Gruppe	Nummer	Version
B 0.3	smc-07-84 vwm-07-04	01

Adjustment of exhaust turbocharger for Red-Diesel

Fig. 1

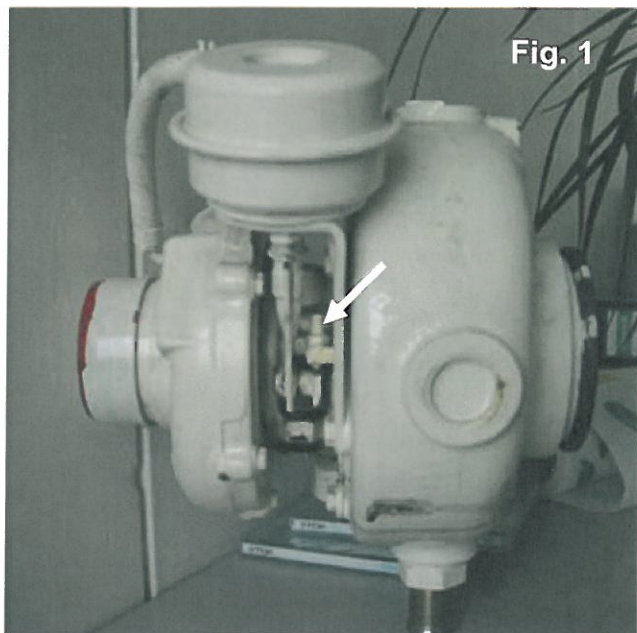
Using Red-Diesel (tax-exempt fuel) leads to higher ignition delays and thus to increasing soot because of lower cetane number.

Partially that soot is as powerful, that the guide vane pitch device of the turbocharger gets blocked.

In bad case an increased boost pressure will be generated on full load, which again generates an error entry and thus the flashing of the system lamp.

In order to suppress the flashing of the system lamp, the set screw at the adjusting bar of the turbocharger (arrowed in Fig.1 and 2.) can be adjusted by turning it clockwise 3 x 360° and additionally by 210° (= 3 ¾ rotations).

The sooting of the engine will not be stopped by this, but the error entry will be eliminated.
